Memorandum

To: Kingdom Community Wind 6216-INDS Project File
From: Andres Torizzo, CPESC, CPSWQ
Date: 3/3/2011
Re: Draft Permit 6216-INDS Comments

Watershed Consulting Associates, LLC (WCA) has prepared the following comments based a technical review of the draft permit 6216-INDS for operational stormwater discharges from the Kingdom Community Wind Project in Lowell, Vermont. These comments have been prepared on behalf of the following municipalities, nonprofit organizations and landowners:

Subcatchment C1: with gravel CN of 98

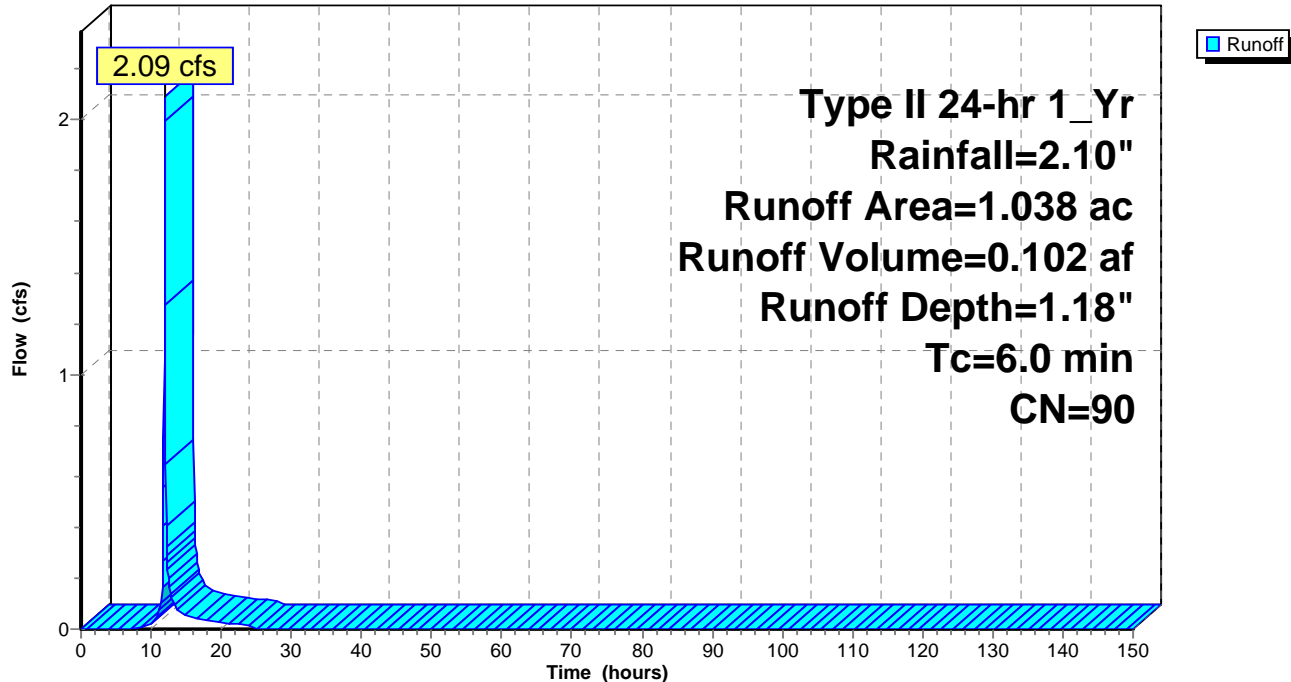
- One example of the impact of updating gravel surface CNs is provided here: Subwatershed C1 includes runoff from a crane pad and crane path to level spreader C1_LS. Using the standard CN of 98 to represent this crane pad and crane path instead of the modified CN values used in this Application will produce a 45% increase in the peak discharge and 36% increase in the total volume of runoff to the level spreader system for the 1-year design storm event (Attachment, Exhibit C). Similar increases could be expected for other design storm events. As a result, the level spreader treatment capacity and downstream flow conditions through the buffer and into the receiving water would need to be reevaluated for compliance with applicable treatment & control criteria.

- The runoff modeling analysis should be revised to include new CN values for gravel impervious surfaces, and resulting stormwater peak flows/velocities and volumes should be reevaluated on a project-wide basis. The reevaluation should include at a minimum:
